Campaign Service BULLETIN

BULLETIN NUMBER:
CB08-J-001C

SUPPLY PUMP CONNECTING PIPE FUEL LEAK SAFETY RECALL CAMPAIGN 08V-251

This bulletin supersedes campaign bulletin CB08-J-001B. This bulletin is being revised to correct labor hour information. Please discard previous bulletin CB08-J-001B.

Figure 1

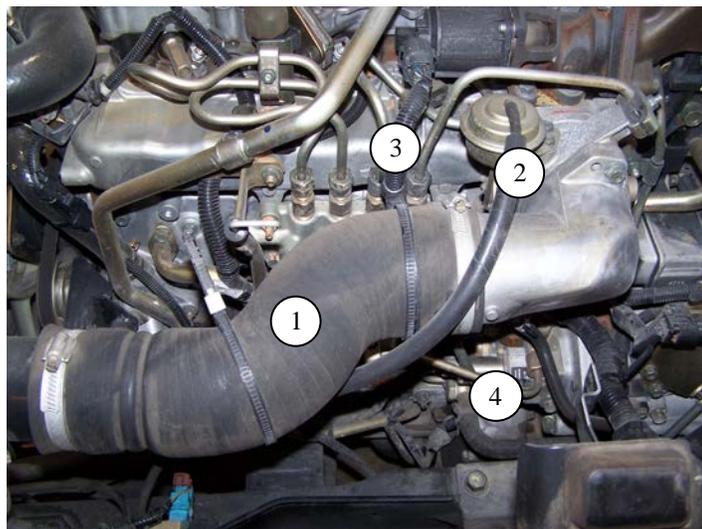
1. Tilt up the cab. Insert the lock pin. (**For Crew Cab Model** - Remove the driver's seat cushion and inspection panel to access the engine compartment.)
2. Remove the intake duct for access. See figure 1.

Figure 2

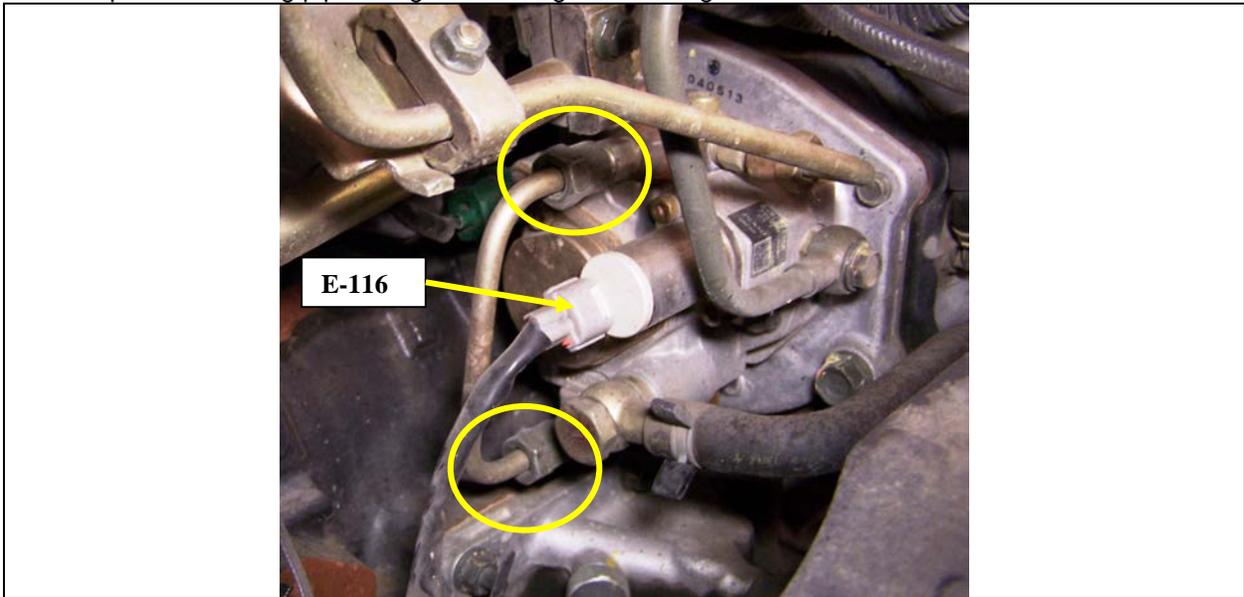
3. Inspect connecting pipe fittings for leaking fuel. See figure 2

Figure3

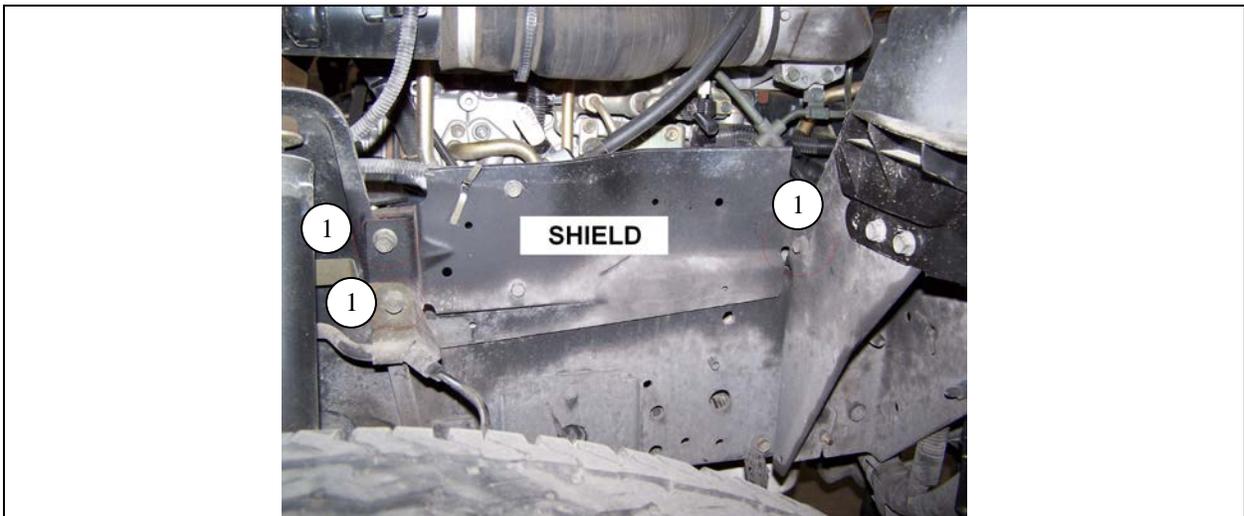
- 4. If no leak is found, go to step 5. If a leak is found, replace the supply pump as outlined in the appropriate service manual. After replacing the supply pump go to “Applying the Campaign Label”.
- 5. Disconnect the Throttle Valve vacuum hose. See figure 1.
- 6. Remove shield mounting bolts and lower the shield for required clearance. See figure 3. (Three mounting bolts)

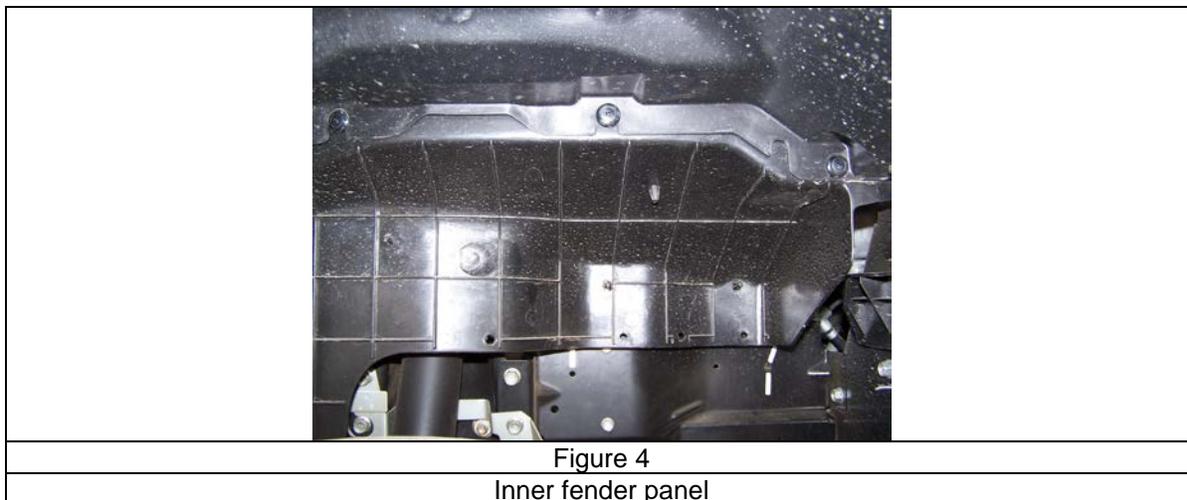
- 7. Disconnect the Fuel Rail Pressure (FRP) Regulator connector E-116. See figure 2.
- 8. **For Crew Cab Model** - Remove the driver side inner fender panel. See figure 4.
- 9. Using the special tool 3300FN pipe socket (SnapOn FRXM 17 or an equivalent), tighten both connecting pipe fittings to 22 lb-ft (30Nm). The torque wrench operation angle should not be greater than 30 degrees. If the operation angle of the special tool is too wide, the tool may interfere with and scratch the pipe. To prevent accidental scratches, apply vinyl tape to the tool. Repeat tightening, alternating sides, until reaching the specified torque.
